Vogtle Electric Generating Plant, Units 3 & 4

COL Application

Technical Specifications

PLANT SPECIFIC TECHNICAL SPECIFICATIONS (PSTS)

Figure B 3.6.8-1 (page 1 of 1)
Time Prior to Coolant Inventory Boiling

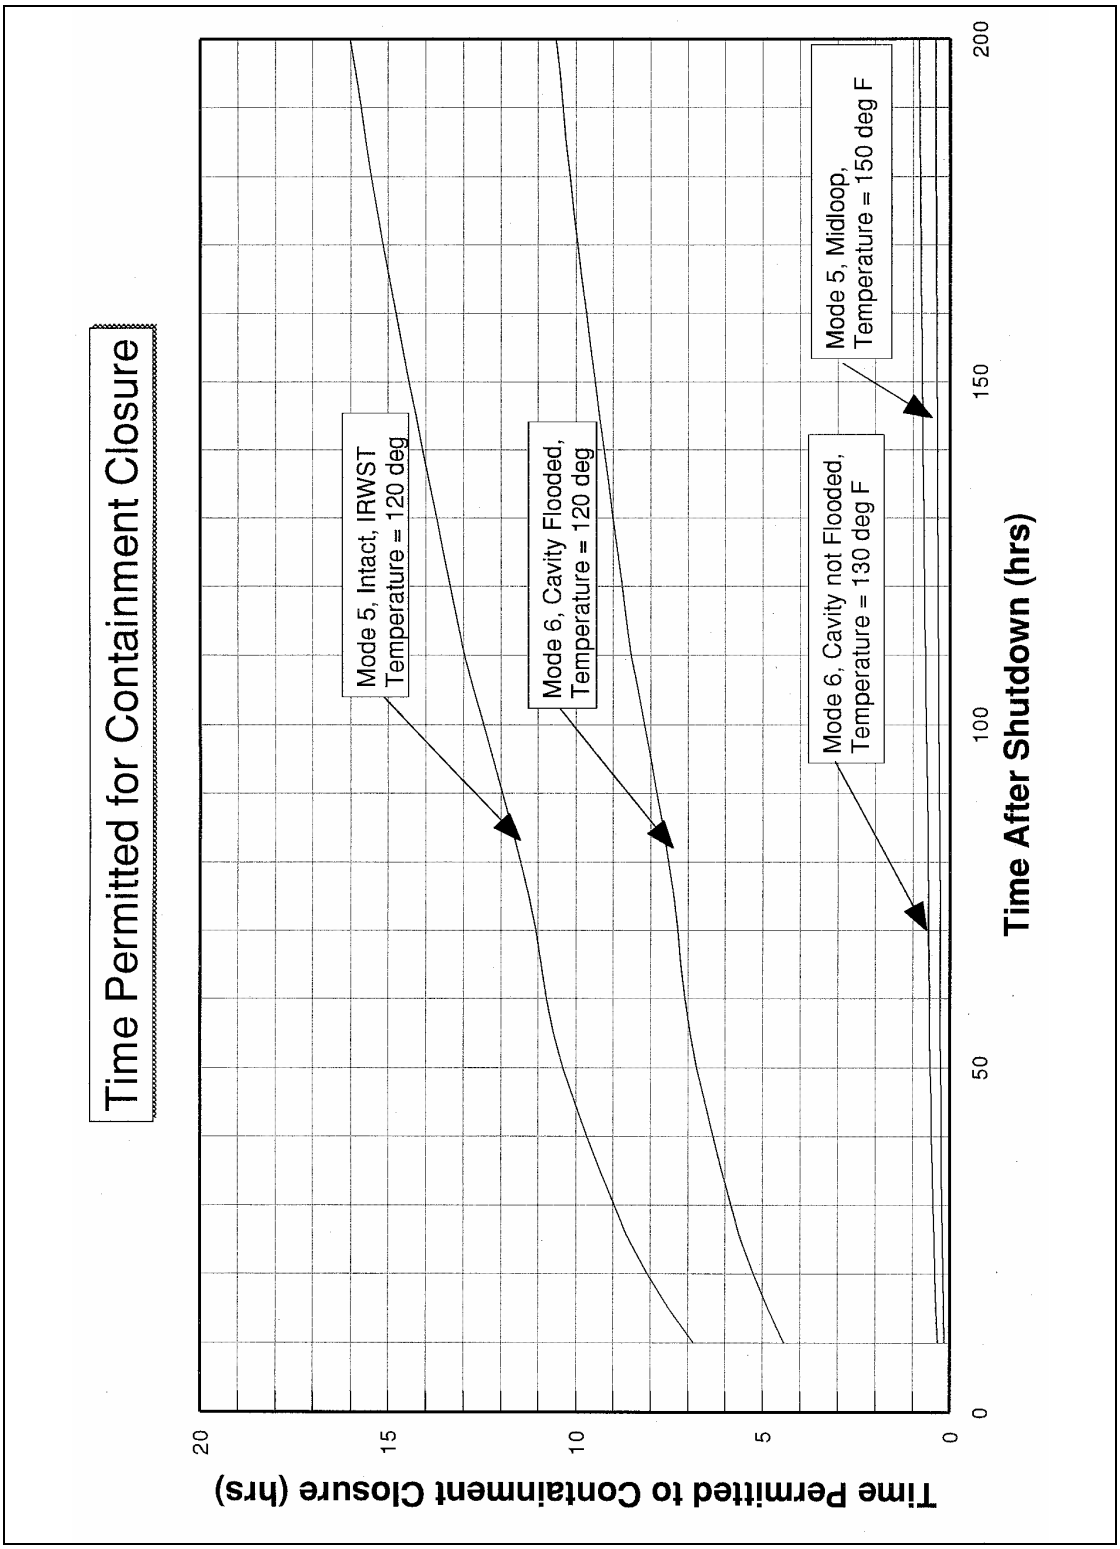
GTS 3.6.8 Bases Figure B3.6.8-1 contains a bracketed curve identifying the time permitted for containment closure in terms of time after shutdown. The entire figure is bracketed. The plant specific curve needed to replace the bracketed value is determined from final fuel data. Therefore, a Bases change is required to provide a plant specific set of curves to replace the bracketed figure. This Bases change will be completed prior to initial fuel load.
